Re: Section 404/401 and Article 24 Permit Application – Residuals Management Unit No. 2
Response to NYSDEC email comments dated October 16, 2013

ENCLOSURE 1
CWM Response to NYSDEC email comments dated October 16, 2013

CWM RESPONSE TO COMMENTS
SECTION 401/404 AND ARTICLE 24/PART 633
JOINT APPLICATION
JULY 2013 SUBMITTAL
(NYSDEC email comments dated October 16, 2013)

New Drum Building Design Drawing (dated December 7, 2011)
Revised New Drum Building Design Drawing C-5 (dated May 30, 2013)
Revised New Drum Building Design Drawing (dated October 22, 2013)

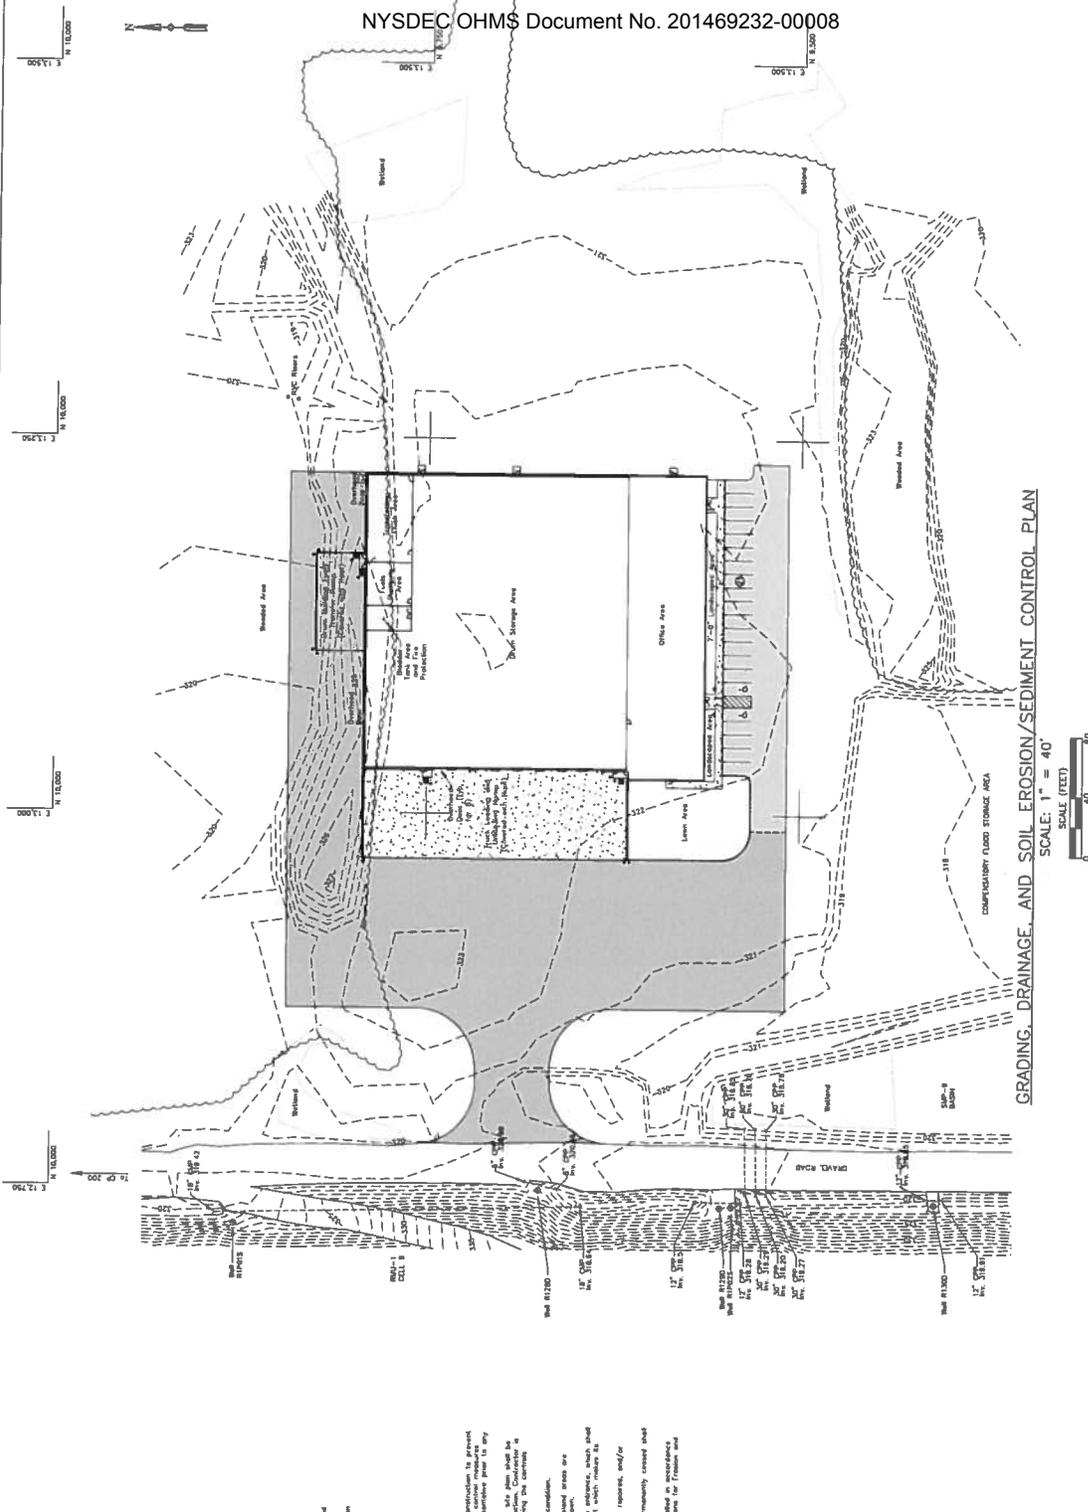
The revisions made to the Building footprint following my November 2012 site inspection (which extended the Wetland RV-8 boundary a few hundred feet south), are helpful. However, before I can be comfortable accepting that CWM minimized impacts to the adjacent area at this location (and therefore potential risks of impacts to Wetland RV-8), I need more details demonstrating that CWM down-sized the footprint of the Building and shifted it southward (away from Wetland RV-8) to the greatest degree practicable. I saw nothing in the Sept 25, 2013 letter to the Corps (or other project material) that specifically addressed that.

It is essential that CWM maximize the buffer width at this location, especially considering the nature of this facility. For example, I believe there are real concerns about the potential risk for discharge into the wetland when the "Drum Building Fuels Transfer Ramp" along the north side of the building is <50 feet from the Wetland RV-8 boundary, as shown on the revised grading plan. CWM needs to clearly explain how will those risks be minimized.

Please check on the accuracy of the Wetland RV-8 delineation boundary in relation to the topographic contours and building footprint shown on the revised (May 30, 2013) plan as it simply doesn't look right. I clearly recall the wetland configuration I inspected on November 6, 2012 and am sure the southern boundary did not extend uphill as much as 5 feet along the north side of the existing fill piles. I am afraid that the EDR flagging was placed at the south edge of the very thick shrub growth on the fill piles instead of at the toe of the fill piles where the wetland boundary truly ends. While that would normally not be a major concern for a project placed outside the wetland proper, it is fairly significant for a project built very close to the wetland boundary where the applicant needs to maximize remnant buffer. EDR and/or I may need to revisit this (potentially with another field inspection by EDR to refine the wetland boundary). Please first verify the shapefile accuracy.

The size and location of the new DMB were selected for various reasons including; market analysis, amount of onsite open area available for development, no federal wetlands or state freshwater wetlands within the footprint of the building development area, and requirement for containing stormwater from operational areas. The location is an open field with an access road and active landfill RMU-1 located to the west, wooded areas located to the north, east, and southeast, and stormwater management features located to the south. The new DMB location was originally designed based on wetlands delineation performed by EDR in 2009. EDR concluded that there were no federal wetlands directly in the proposed footprint and that state freshwater wetland RV-8 was located approximately 500-feet to the north-northeast. See attached drawing for original grading plan design dated December 7, 2011. Additional design criteria included the requirement that stormwater from operational areas must be directed to a permitted/constructed stormwater management point (SMP09), could not disturb wetlands (federal or state), and could not disturb a compensatory flood storage area. The DMB design submitted in June 2012 met these criteria.

Therefore, CWM redesigned the location of the building and redesigned the driveways, parking areas, grading plan, and stormwater management features. A parking area was originally located on the south side of the building. For the redesign, the parking area was shifted to the southwest corner of the building. Additionally, the landscape area south of the office portion of the building was reduced in size. Consequently, the north to south footprint dimension of the building and paved areas was reduced by approximately 52 feet. Additionally, the south boundary of the building footprint/paved area was shifted approximately 62 feet to the south. The building and paved area footprint was moved as far south as practicable without filling federal wetlands and the compensatory flood storage area for 12-mile creek.

The current DMB design will not impact freshwater wetland RV-8, however, the 100-foot adjacent area will be impacted. The 100-foot adjacent area that will be impacted includes mostly open field areas. The location of the DMB cannot be further moved to the south because to do so would directly impact a federal jurisdictional wetland, a compensatory flood storage area for Twelve Mile Creek, and stormwater management point No. 9 (SMP09). See attached drawing for a revised grading plan design with a revision date of October 22, 2013.

The Drum Building Fuels Transfer Ramp will be a Part 373 Permitted Container Storage Area. The design of the Fuels Transfer Ramp is provided on Drawing C-5 included in Attachment D of the Part 373 Permit Modification Application/Request for RMU-2 (August 2013). The Part 373 Permit Modification Application/Request also includes regulation required secondary containment calculations. Secondary containment will be provided by a sloped concrete ramp. An approved sealant, (e.g., CHEMTEC One) will be applied to the concrete area of the ramp. This ramp will be used to transfer compatible liquids from drums inside the new DMB to bulk tankers located on the ramp. The ramp is sized to accommodate two tankers to also allow the transfer from tanker to tanker. The dock area will be covered with a roof, to minimize stormwater accumulations and to provide protection for personnel during inclement weather. Any spills that may occur in the fuels ramp will be contained by the secondary containment. The ramp is inspected daily and during transfer operations. Any potential spills within the secondary containment of the ramp will be cleaned up immediately in accordance with the Part 373 Permit. Any accumulations of stormwater within the secondary containment of the ramp must also be removed within 24 hours of the end of a storm event in accordance with the Part 373 Permit. Therefore, there is minimal or no risks of liquids from the fuels transfer ramp to enter Wetland RV-8 or the stormwater management system.

CWM checked with design engineer for the new DMB (Great Lakes), the firm that performed a detailed survey of the area (Ensol, Inc.), and EDR for the accuracy of the RV-8 boundary. Apparently, the GPS shapefiles from EDR were not placed accurately on the design drawing prepared by Great Lakes due to software transfer issues. It was confirmed that the boundary of the RV-8 wetland boundary on new DMB drawing C-3 (dated May 30, 2013) is not accurate. Therefore, the boundary of RV-8 has been revised as shown on revised DMB Drawing C-3. Consequently, there is additional buffer area between the new DMB building development and Freshwater Wetland RV-8. CWM does not feel that it is necessary for further field verification at this time.
